Access Compliance Report

Public Rights-of-Way

(Curb Ramps)

Intersection ID: 52249	Main Street: PARK_RD	Cross Street: N/A	Location: NW
ADA ID: 1EE7C829614C	Ramp Type: Perp	Initial Pass/Fail: Fail	Overall Compliance: No
Severity Score: 13.75			
Codes/Mitigation Info/Possible Solution		Field Measurements/Component Compliance

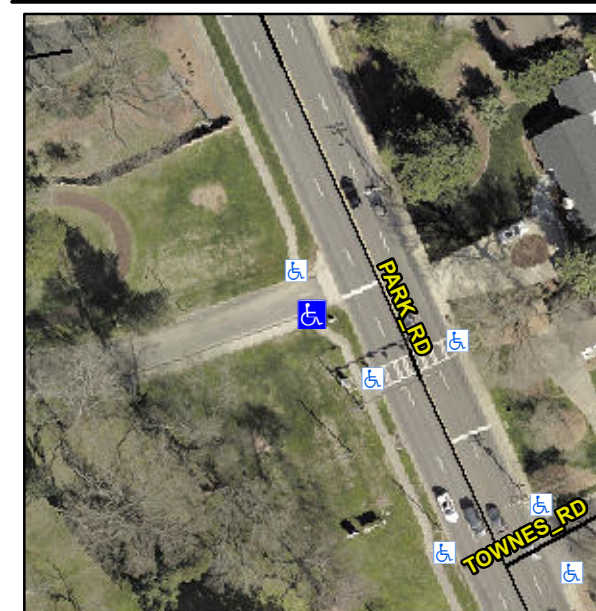
Not Found, R304.2.2, R304.5.3

Compliance	Description	Data	Compliance	Description	Data
N/A	Ramp Length (in)	79.0	No	Ramp Slope (%)	8.5
Yes	Ramp Width (in)	59.0	No	Ramp XSlope (%)	2.1
N/A	Flare Type LT	N/A	N/A	Flare Type RT	N/A
N/A	Flare Slope LT (%)	N/A	N/A	Flare Slope RT (%)	N/A
N/A	Flare Traversable LT?	N/A	N/A	Flare Traversable RT?	N/A
N/A	Landing Length (in)	N/A	N/A	DWS Provided?	N/A
N/A	Landing Width (in)	N/A	N/A	DWS Contrast?	N/A
N/A	Landing Slope (%)	N/A	N/A	DWS Length (in)	N/A
N/A	Landing X Slope (%)	N/A	N/A	DWS Full Width?	N/A
N/A	Landing Curb? (Y/N)	N/A	N/A	DWS Offset (in)	N/A
N/A	Shared Landing?	N/A			
N/A	Gutter Ponding?	N/A	N/A	Gutter Slope (%)	N/A
N/A	Gutter Lip Ht (in)	N/A	N/A	Gutter X Slope (%)	N/A
N/A	Painted X Walk1?	No	N/A	Painted X Walk2?	N/A
	X Walk 1 Direction	To NW		X Walk 2 Direction	N/A
N/A	X Walk 1 Width (in)	N/A	N/A	X Walk 2 Width (in)	N/A
	X Walk 1 Slope (%)	4.1		X Walk 2 Slope (%)	N/A
	X Walk 1 X Slope (%)	1.6		X Walk 2 X Slope (%)	N/A

Remove & Replace Entire Ramp.
